UNITED STATES PATENT AND TRADEMARK OFFICE

APPLICATION NO.	FILING DATE	FIRST NAMED INVENTOR	ATTORNEY DOCKET NO.	CONFIRMATION NO.
09/737,770	12/18/2000	In-Duk Song	8733.339.00	8950

Office Action Summary	Application No.	Applicant(s)
	09/737,770	SONG, IN-DUK
	Examiner Timothy L Rude	Art Unit 2871

DETAILED ACTION

FIG.2E

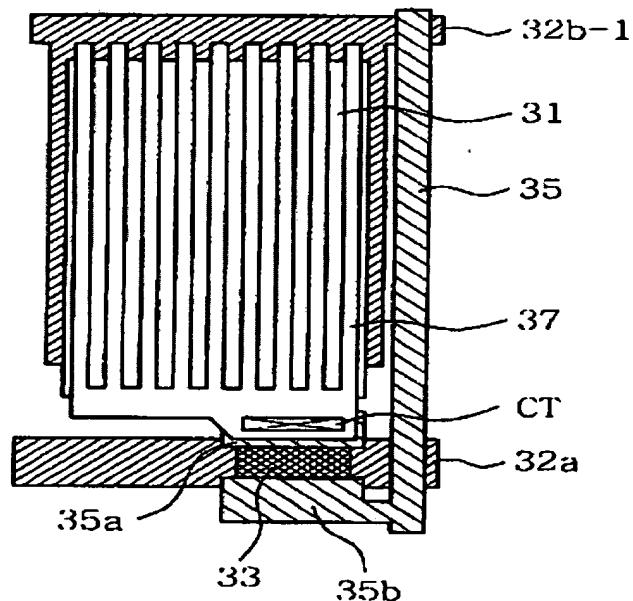
Jeon discloses in Figures 2A-2E, an in-plane switching LCD device comprising: a gate line, 32a, on a first substrate; a data line, 35, on the first substrate, the data line being perpendicular (as illustrated) to the gate line; a common line, 32b-1, on the first

substrate, the common line being parallel (as illustrated) with the gate line and being formed of a metal (Cr for both gate line and common line; col. 2, lines 49-58, especially lines 55-58); a pixel electrode, 37, (ITO; col. 3, lines 18-22) and the common electrode, 31, (ITO; col. 2, lines 64-67) being formed of a transparent conductive material (ITO); and a liquid crystal layer between the first and second substrates (inherent to comprising a LCD device) made by a method that simplifies the process by reducing the mask number.

As to claim 18, Jeon discloses the LCD device of claim 17, wherein a portion of the common line overlies a portion of the common electrode (Figures 2A-2E, especially Figure 2C, and col. 2, lines 49-67, especially lines 64-67).

FIG. 3

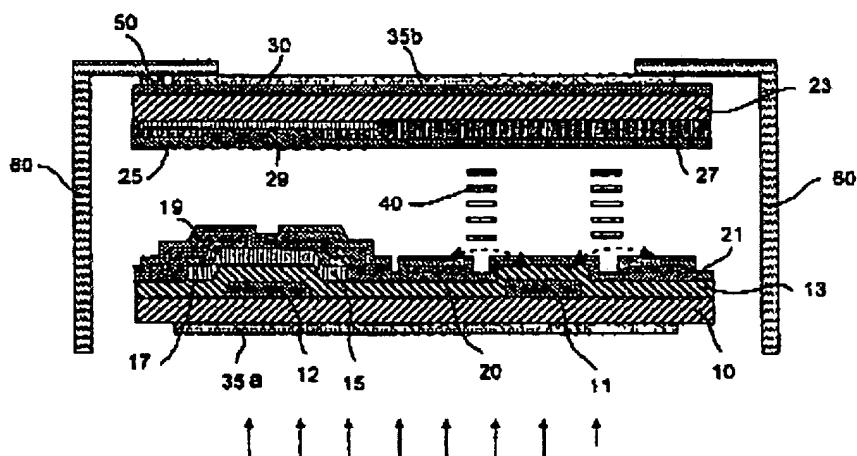
Son teaches in Figure 3, an LCD device, further comprising a light-shielding layer, 25, (Applicant's black matrix) on the second substrate, 23, (para 0029).

Son is evidence that ordinary workers in the art of liquid crystals would find the reason, suggestion, or motivation to use a black matrix on the second substrate to prevent light from leaking around the TFT (first two lines of para 0029).

FIG. 1

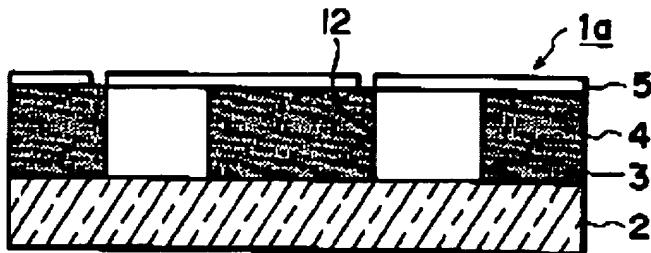
Ishikura teaches in Figure 1 (col. 3, lines 34-54) a device wherein a portion of the transparent electrode, 5, (Applicant's common electrode) overlies a portion of the principle electroconductive layer, 12, (Applicant's common line), to improve conductivity and reduce resulting voltage waveform deformation (or distortion) (col. 1, lines 14-39).

Ishikura teaches in Figure 1 (col. 3, lines 34-54) a device wherein a portion of the ITO transparent electrode, 5, (Applicant's common electrode) overlies a portion of the

Ishikura teaches in Figure 1 (col. 3, lines 34-54) a device wherein a portion of the ITO transparent electrode, 5, (Applicant's auxiliary gate line and auxiliary gate pad) overlies a portion of the principle electroconductive layer, 12, (Applicant's gate line and gate pad), to improve conductivity and reduce resulting voltage waveform deformation (or distortion) (col. 1, lines 14-39).

FIG.1
(PRIOR ART)

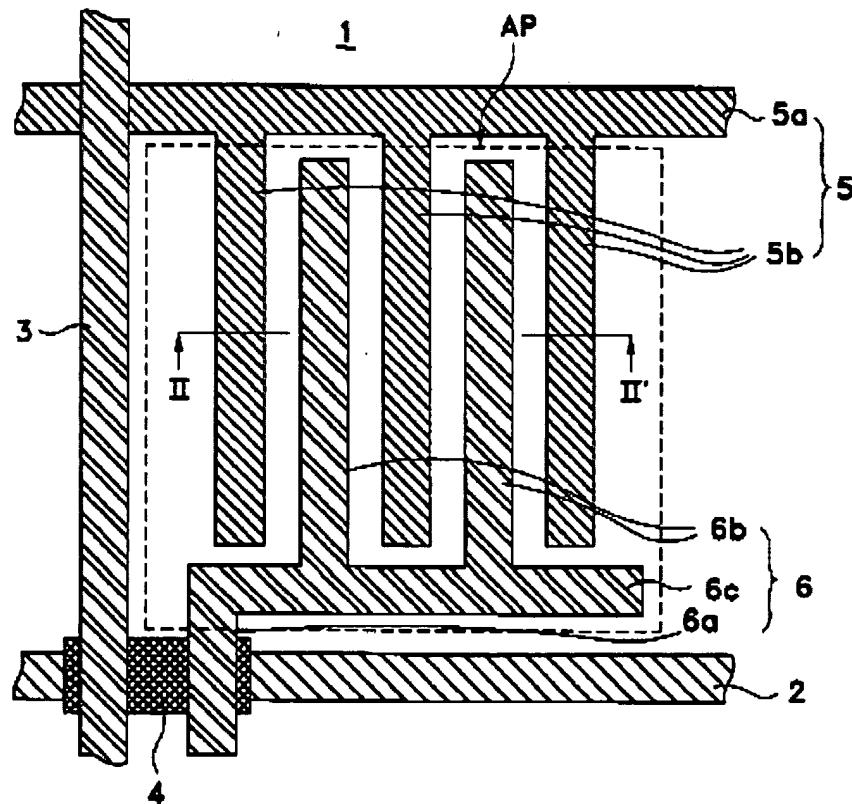
Shin teaches as prior art in Figures 1 and 2 the use of a pixel electrode, 6b, formed of an opaque metal (col. 2, lines 3-6) in order to block a light of the area in which the liquid crystal molecules are not operated in an in-plane switched LCD.

Shin is evidence that ordinary workers in the art of liquid crystals would find the reason, suggestion, or motivation to add opaque metal electrodes in order to block a light of the area in which the liquid crystal molecules are not operated.
